PROPOSED WAIRAU/AWATERE RESOURCE MANAGEMENT PLAN

Proposed Plan Variation No. 49

Industrial 2 Rezoning between Riverlands Industrial
Estate and Cloudy Bay Business Park

Amended Schedule of Changes following Decisions on Submissions

VOLUME 3 – MAPS

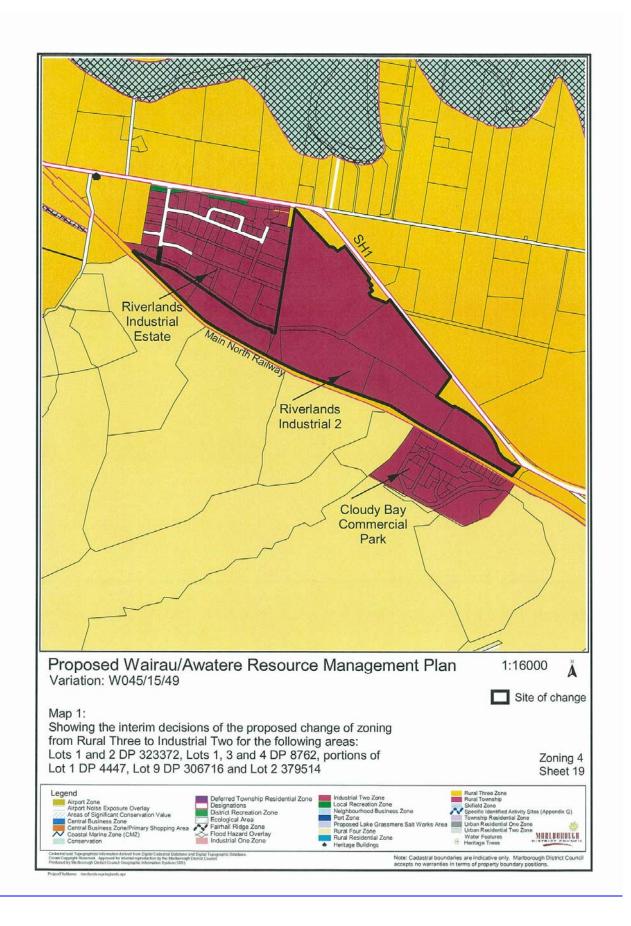
9. Amend Zoning Map 4 and Sheet 19 to rezone Lots 1 & 2 DP 323372, Lots 1, 3 & 4 DP 8762, portions of Lot 1 DP 4447, and Lot 2 DP 379514 from Rural 3 to Industrial 2 as shown on the attached map:

<u>10.</u>	Place a bounda	ry around	the above	lots (includir	ng Lot 9 I	OP 306716)	and label	Riverlands
	Industrial 2
